St Marys Intermodal Modification 1

Rail refurbishment works package

State Significant Development Modification Assessment
(SSD 7308 MOD 1)

Published by the NSW Department of Planning, Industry and Environment

Figure 6 | Rail refurbishment works engineering drawings – Sheet 02 of 05 (Source: Applicant's Modification Report)

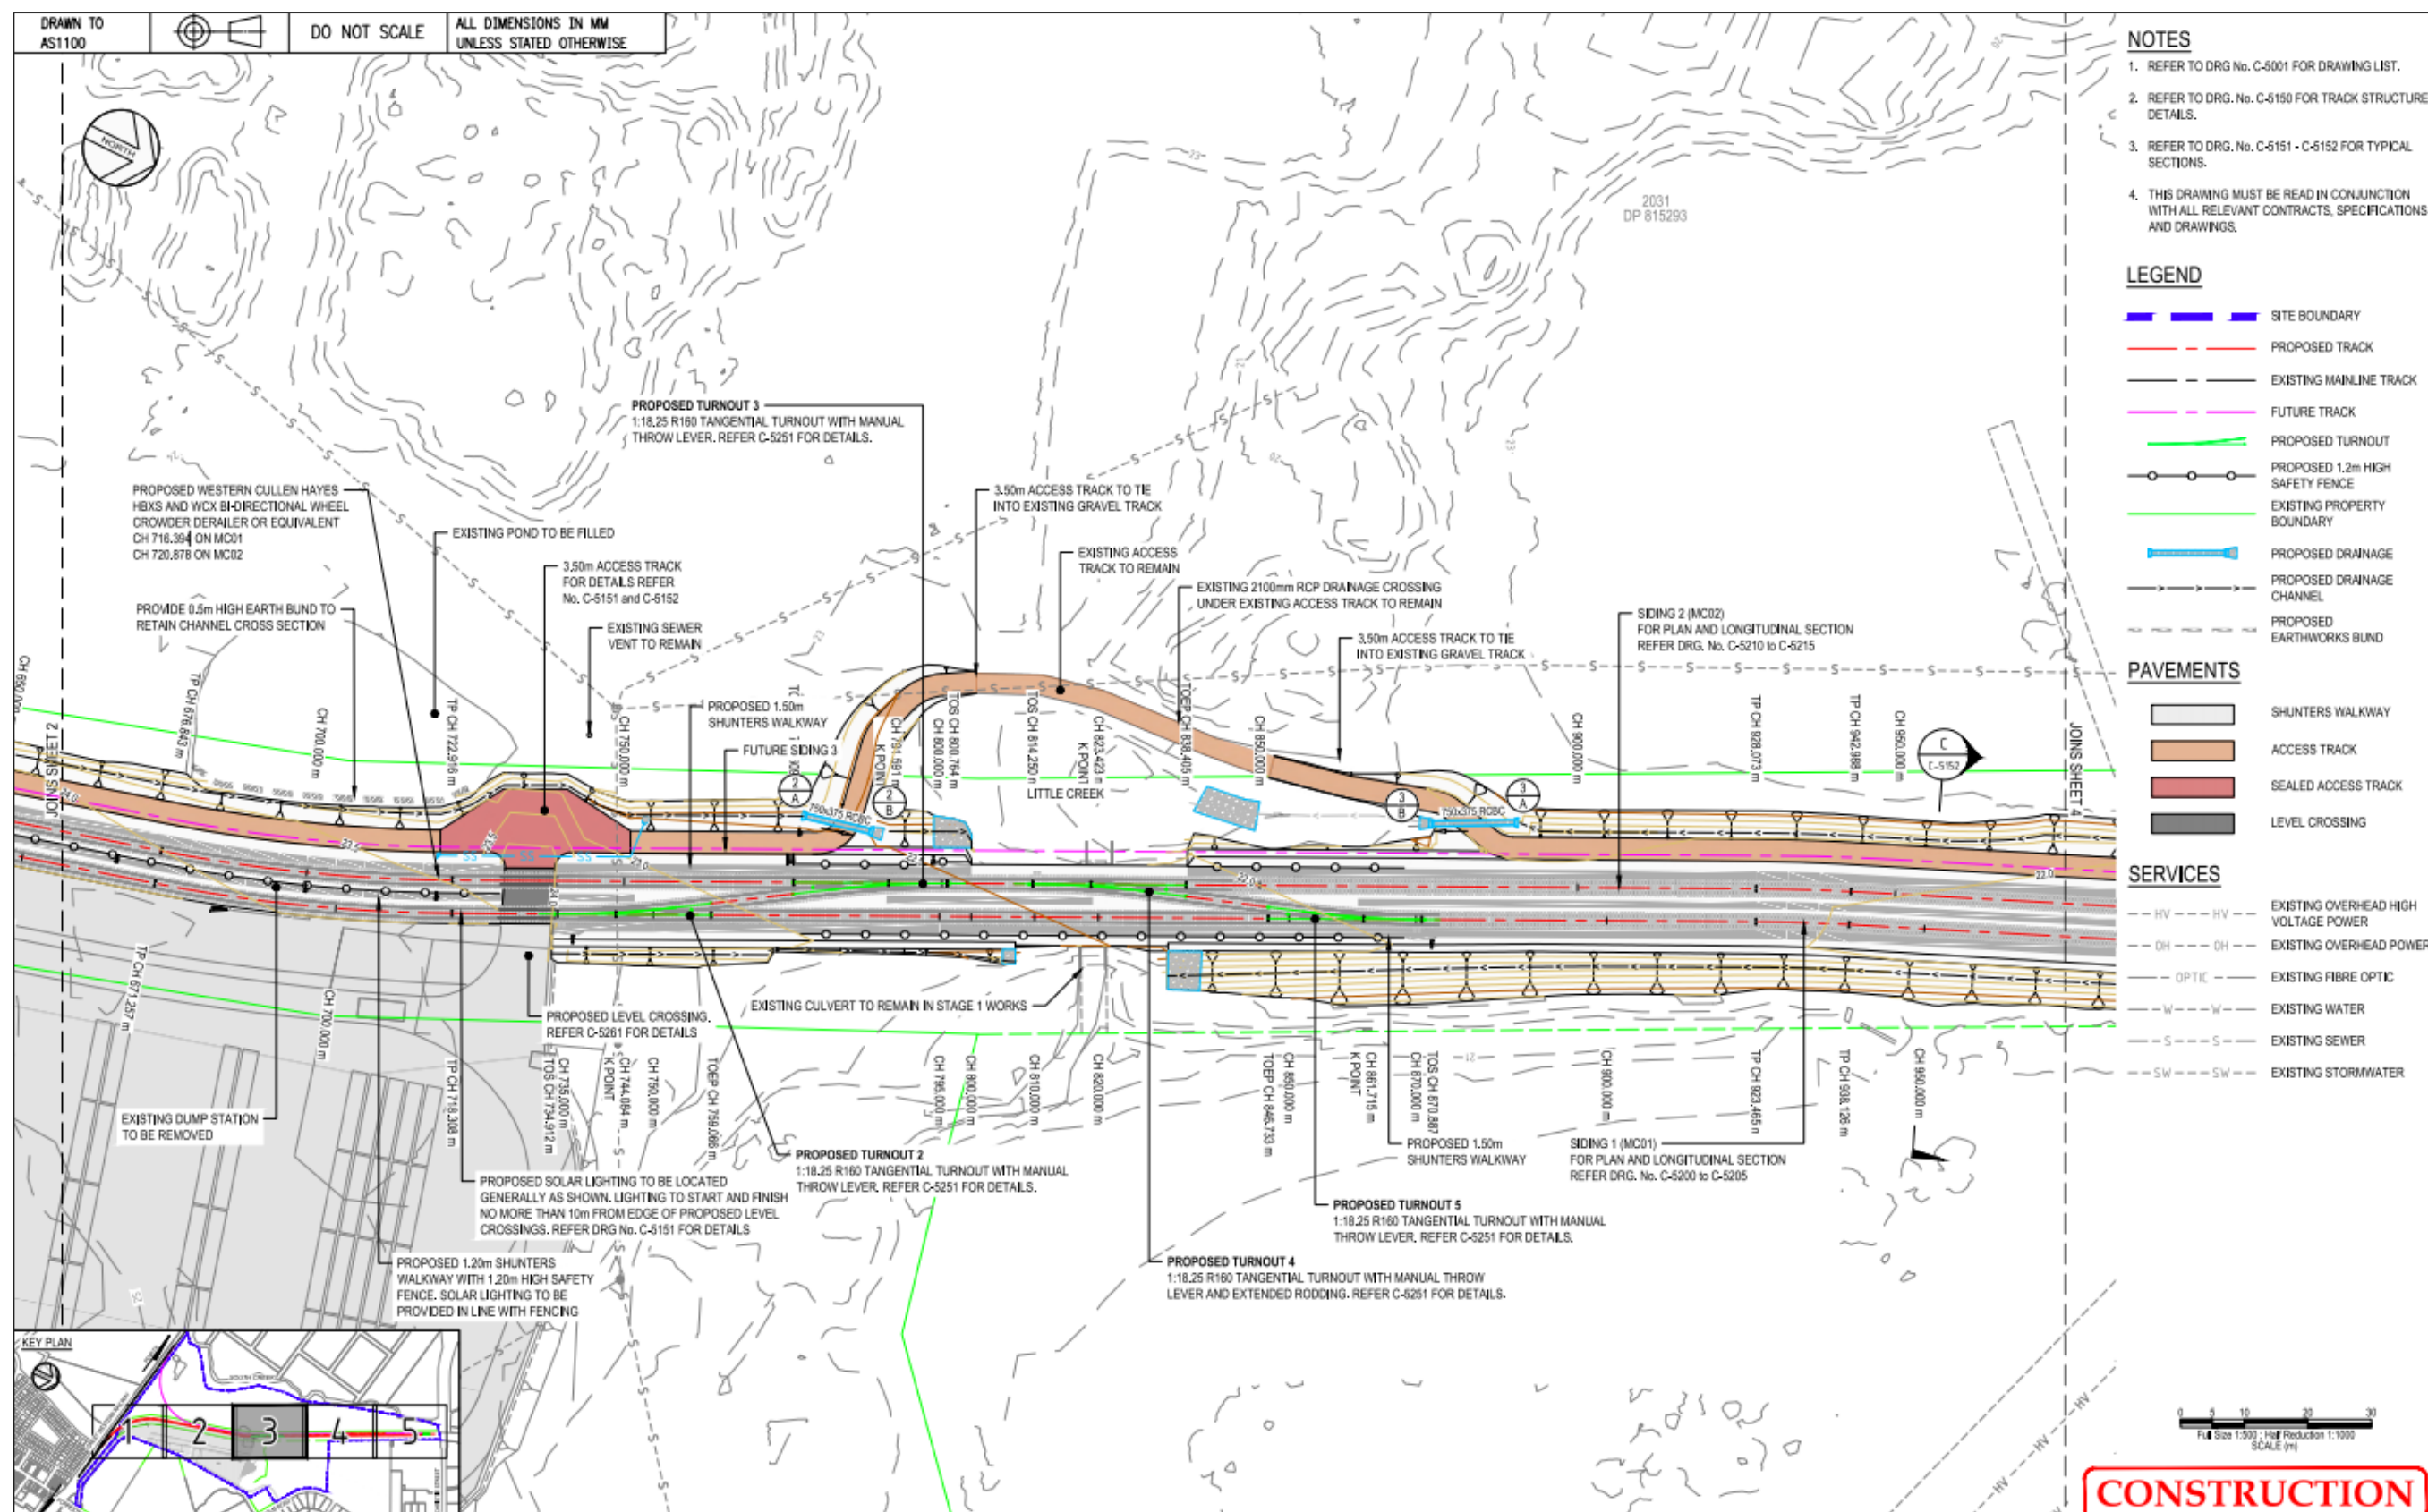
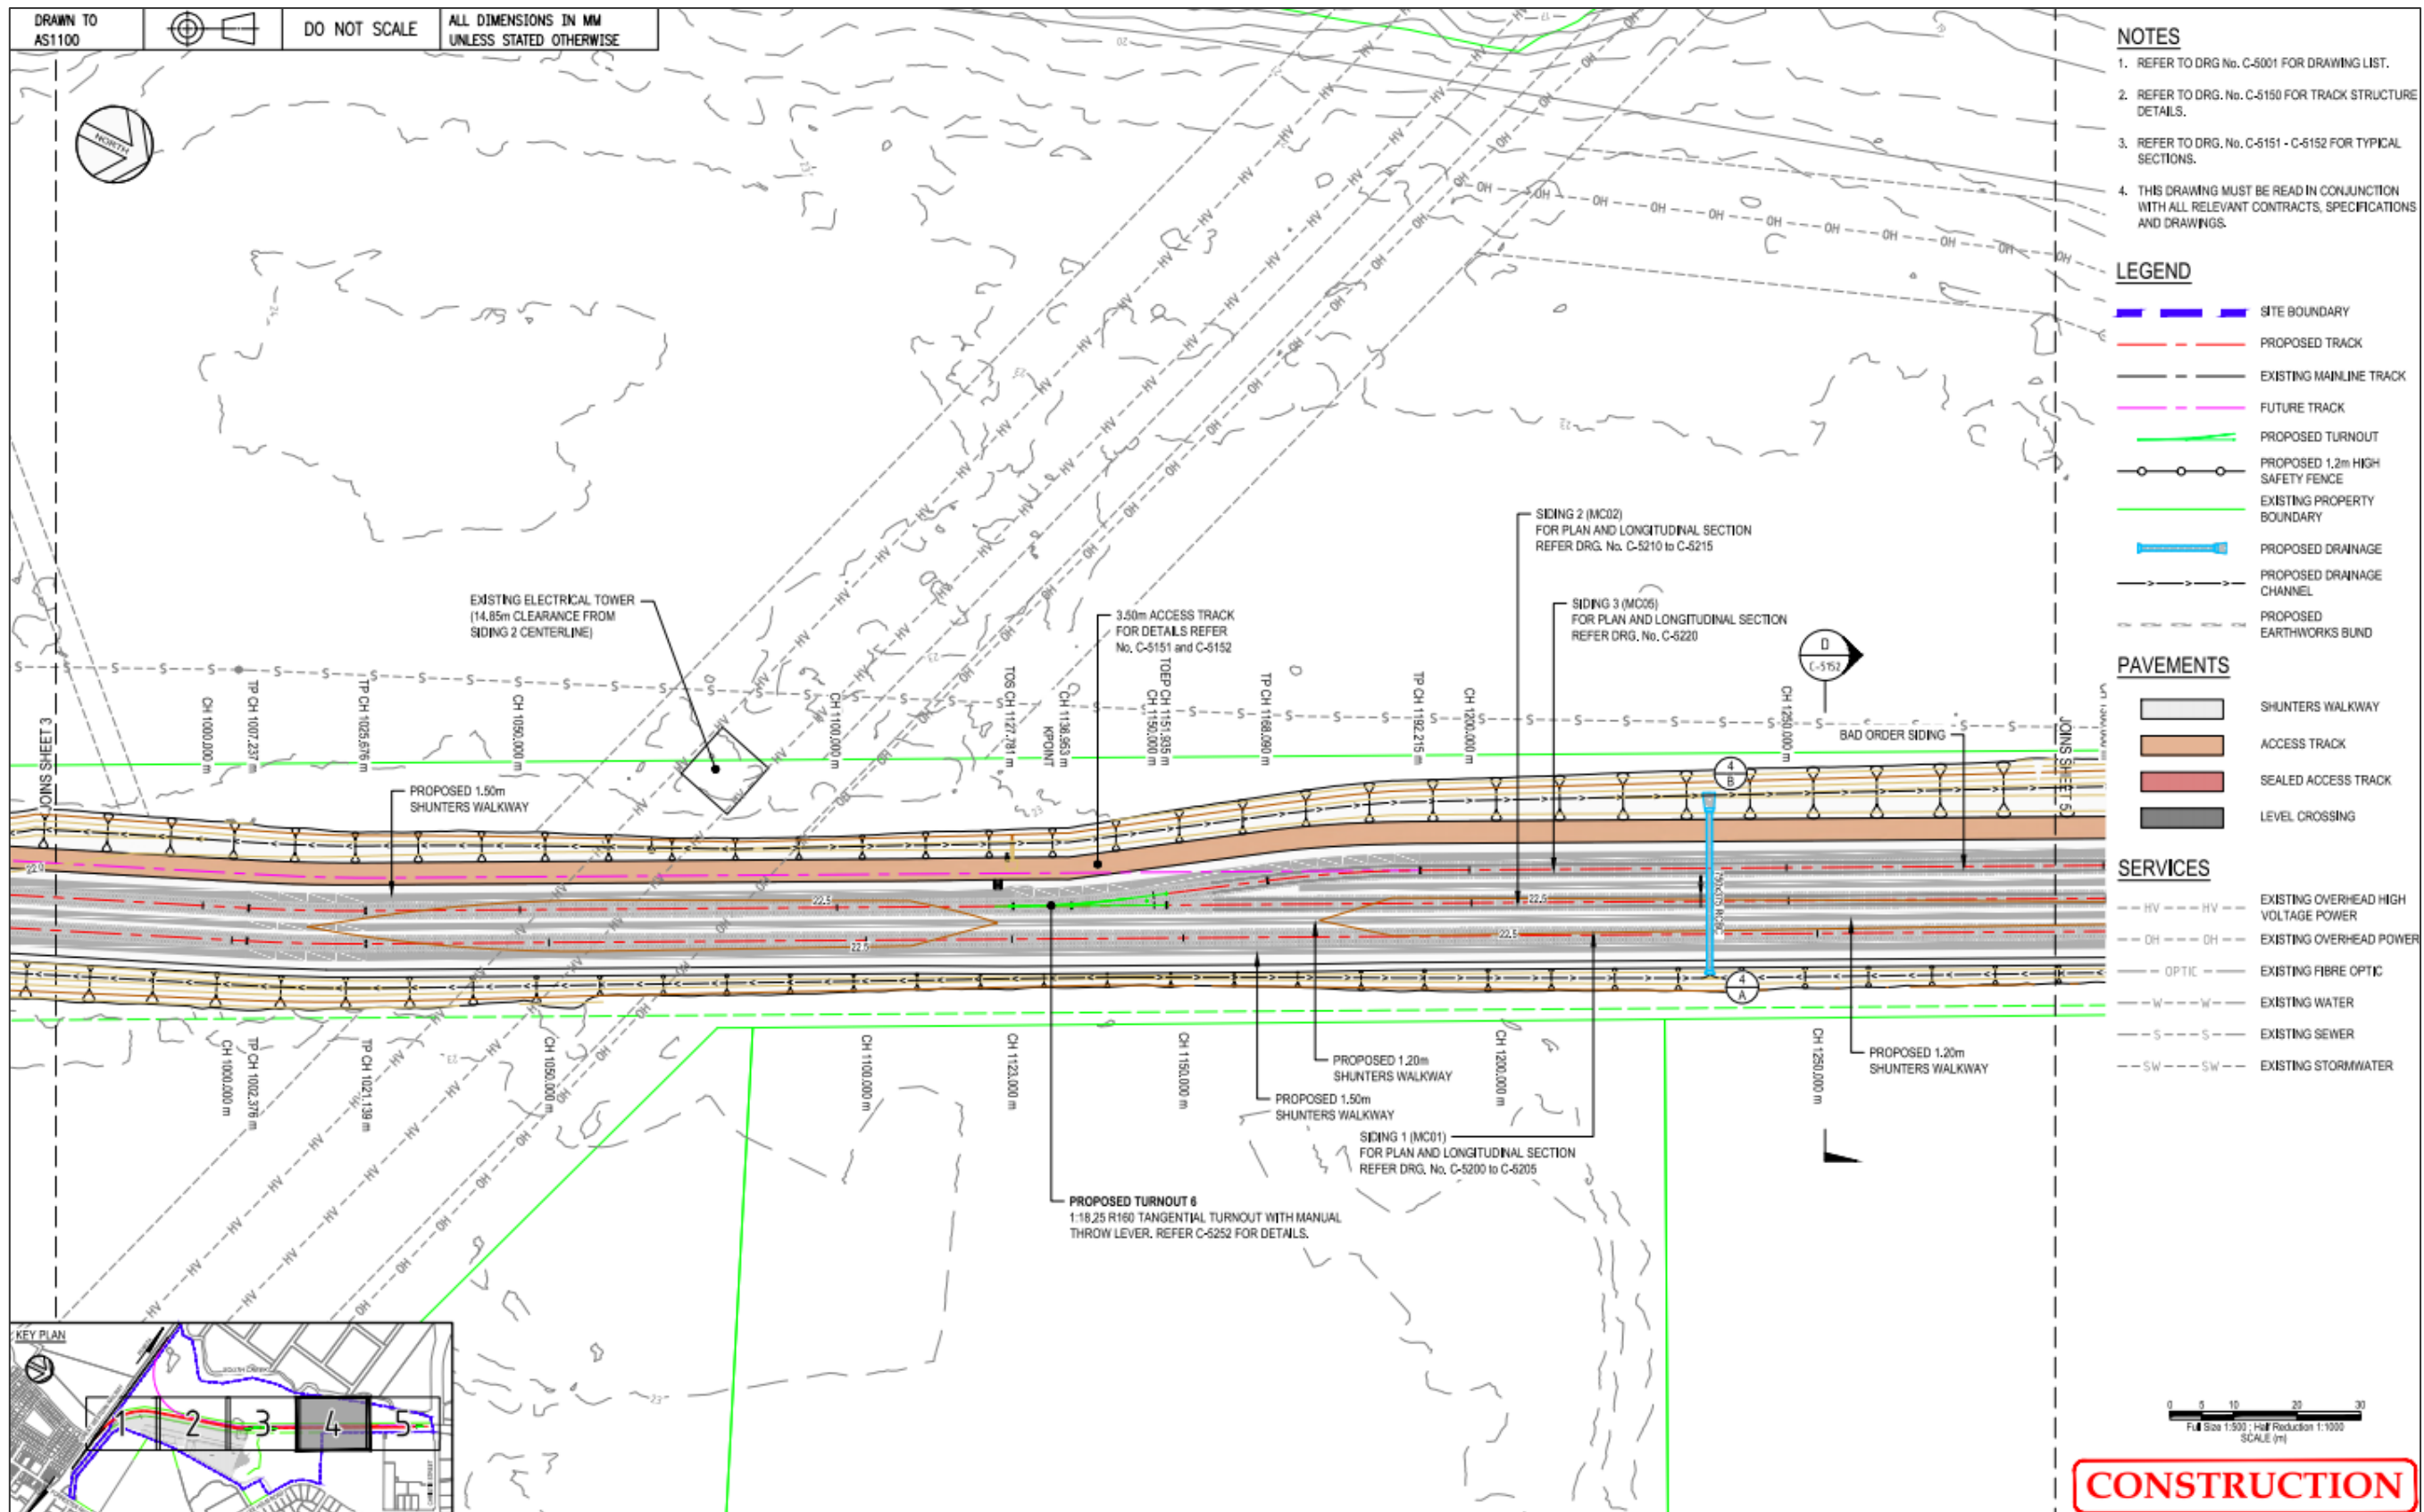
The proposal seeks to construct a 3.5 m wide one-way access track adjacent to the rail sidings and upgrade two existing level crossings (**Figure 5** to **Figure 9**). The access track would utilise an existing gravel access track that traverses Little Creek, to the immediate west of rail siding 2. The access track is proposed to run the full length of the rail sidings to allow light vehicles to transport locomotive drivers, enable access for maintenance works and allow track inspections during operation of the development.

As part of its submission on the modification application, Council requested a flood safety assessment be undertaken for the section of access track that traverses Little Creek, to assess flood velocity and depth for the safe access of vehicles, including possible warning signage, depth markers and potential upgrades to the pipe culvert to achieve flood safe access. As part of the RtS, the Applicant advised that the low point in the access track is subject to high hazard flood conditions during the 1% AEP event during both existing and post-developed peak-flow scenarios. To manage potential flooding impacts, the Applicant proposes to implement flood warning signage at the low point across Little Creek, enforce conditions for use of the access track in the Emergency Management Plan for the development, and restrict use of the track during flooding events. The Applicant also considered that upgrading the pipe culvert crossing Little Creek is not considered appropriate, as this would require raising the access track which has the potential to cause additional flooding impacts. The Department considers this approach to be acceptable.

Further, EESG recommended that an Emergency Management Plan be prepared for the development, to evacuate workers and users of the rail works area during a flood event. EESG also recommended the Applicant consult State Emergency Services during preparation of the plan, as the site is partially within the Hawkesbury-Nepean Regional flood extent. In response to advice provided by EESG, the Applicant advised that a site-specific Flood Management Plan would be implemented during operation of the development and would be maintained by the operator of the site.
